TVA-BFN-TS-361

**BROWNS FERRY NUCLEAR PLANT (BFN) - UNITS 1, 2, AND 3 -
TECHNICAL SPECIFICATION (TS) 361 - RESIDUAL HEAT REMOVAL
SERVICE WATER SYSTEM (RHRSW) TS REQUIREMENT FOR STANDBY
COOLANT SUPPLY AND TS 3/4.2.F INSTRUMENT NUMBER CHANGES**

PROPOSED TECHNICAL SPECIFICATION (TS) CHANGE TS-361 DESCRIPTION AND EVALUATION OF THE PROPOSED CHANGE

System Operation (See attached Figure)

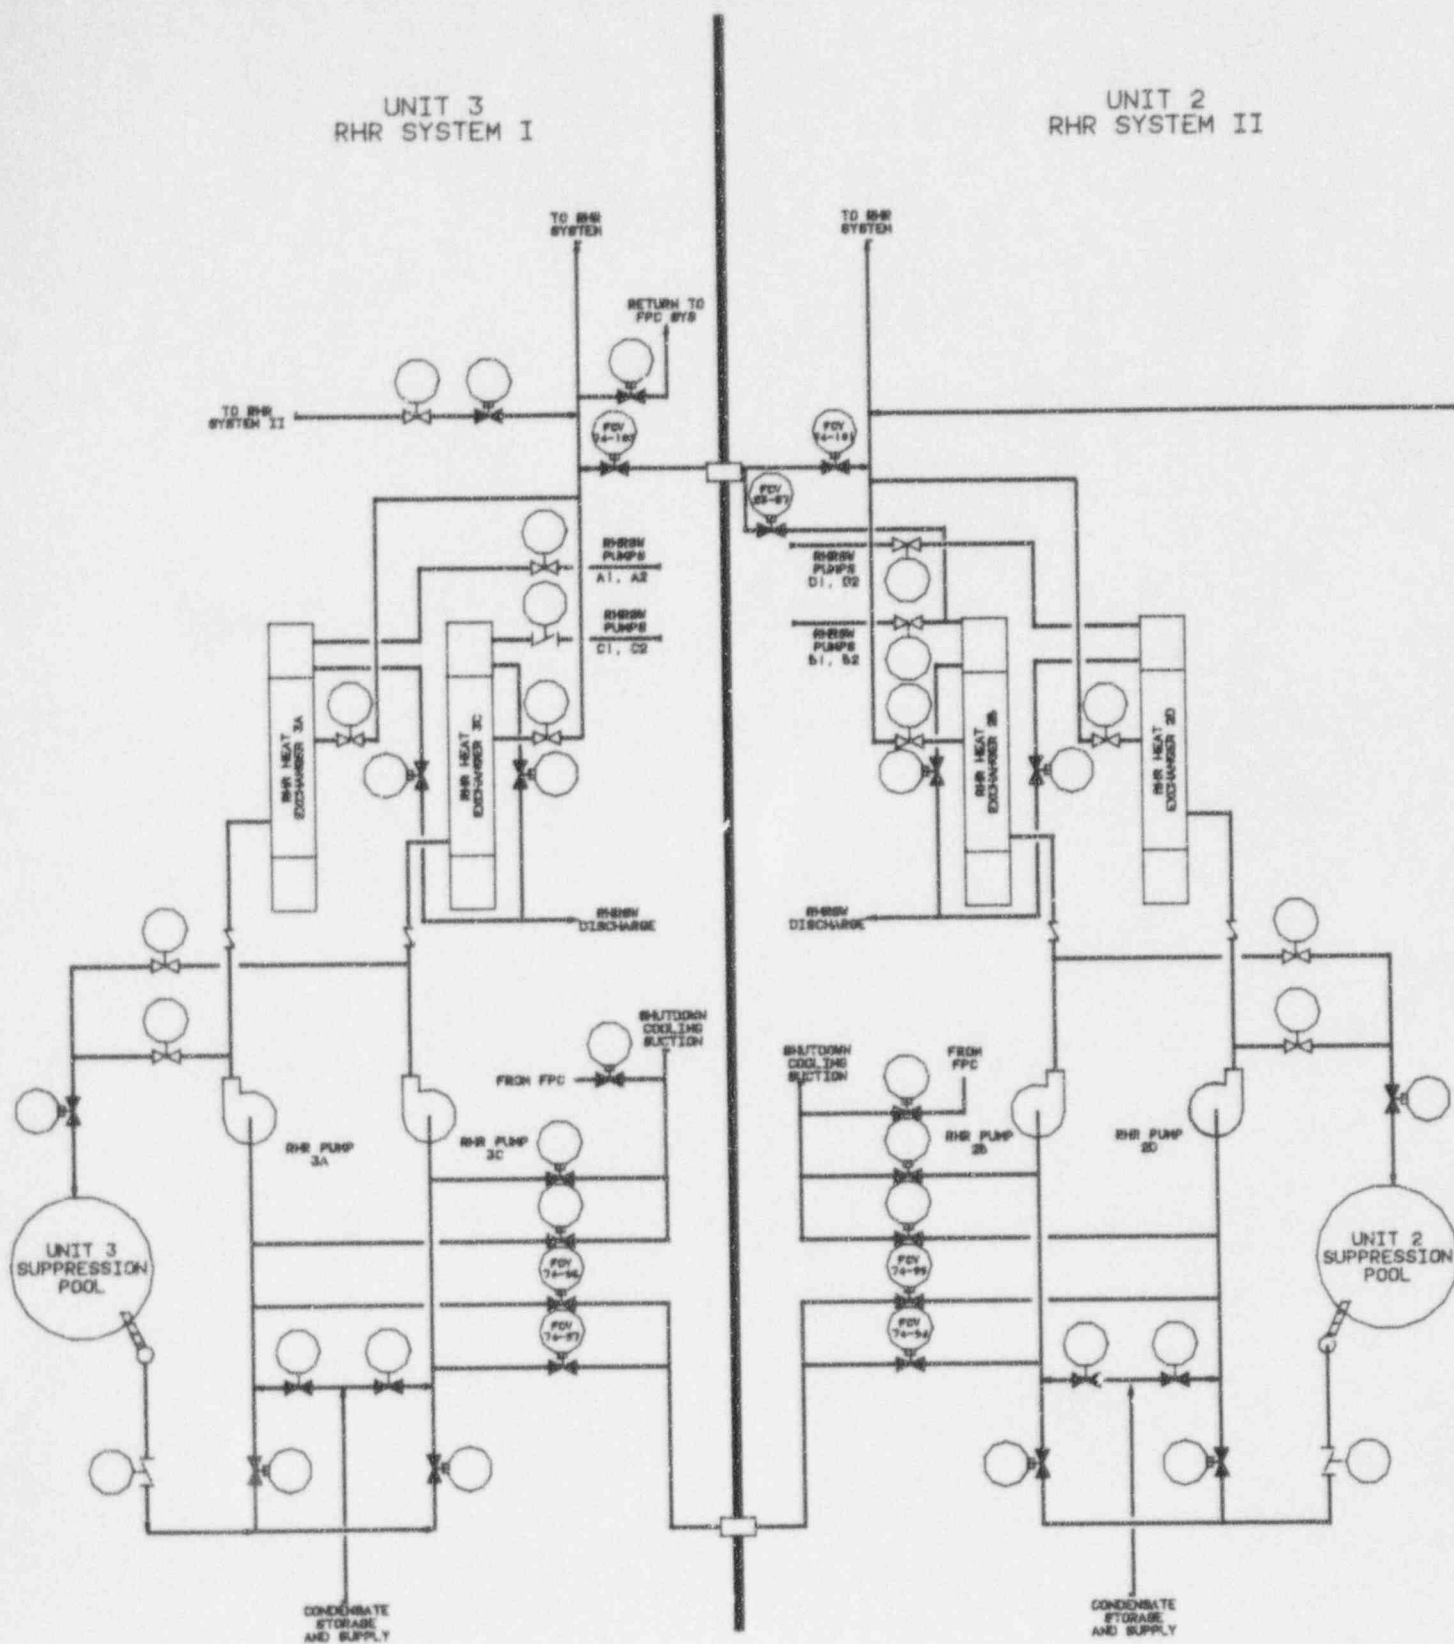
The standby coolant supply connection provides a tie between the RHRSW system (which circulates raw water for cooling through the RHR system heat exchangers) and the RHR system. This connection allows the RHRSW pumps to supply raw water directly to the RHR system (via valves 1-FCV-23-57 or 2-FCV-23-57) which then can be directed to the reactor vessel, containment, or suppression pool utilizing the RHR system flowpath. One standby coolant supply connection (1-FCV-23-57) can supply Unit 1 RHR system Loop II or Unit 2 RHR system Loop I utilizing RHRSW pumps D1 or D2. The other standby coolant supply connection (2-FCV-23-57) can supply either Unit 2 RHR system Loop II or Unit 3 RHR system Loop I utilizing RHRSW pumps B1 or B2.

The standby coolant supply connects to the RHR system cross-connect piping between the RHR pump discharge lines exiting the RHR heat exchangers. Therefore, in order to initiate standby coolant supply for a unit, the associated RHR system cross-connect valve must also be opened. The following table shows the relationship

RHR system cross-connect valves 2-FCV-74-101 and 3-FCV-74-100 will be in the closed position with their power supply breakers in the open position to comply with the Appendix R design requirements. These two valves are utilized for the standby coolant supply to Unit 2 RHR system Loop II and Unit 3 RHR system Loop I. This will require manual operator action to restore the power to the affected valves prior to their operation to place standby coolant supply in service.
